Interpretation Number: 1-07/98
Topic: Format of the OUI in PHY Identifier register
Relevant Clauses: 22.2.4.3.1
Classification: Unambiguous

Interpretation for IEEE std 802.3u-1995

Figure 22-12—Format of PHY Identifier

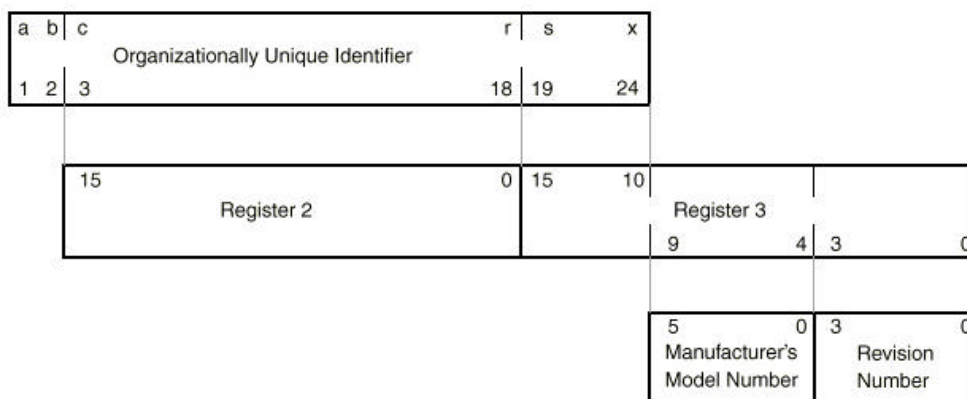
I am trying to understand clause 22.2.4.3.1 of IEEE Std 802.3u-1995. The clause explains how the OUI (Organizationally Unique Identifier) maps to MII (Media Independent Interface) Management Registers 2 and 3. Although we have an IEEE assigned OUI of XX-XX-XX, I cannot figure out how to store our OUI in these Registers.

1. It is unclear to me whether the OUI provided has a format of bits 1 to 24 or as bits 24 to 1.
2. Also, the specification refers to IEEE Std 802-1990. However, is the specification implying that we should store the data in the registers as it will be used to form our Universal Address?

Of particular reference should be the bit designations, ‘a’ through ‘x’, provided in Std 802-1990 Figure 5-2. These bit designations also clearly appear in std 802.3u-1995 Figure 22-12 of subclause 22.2.4.3.1 which is also reproduced below.
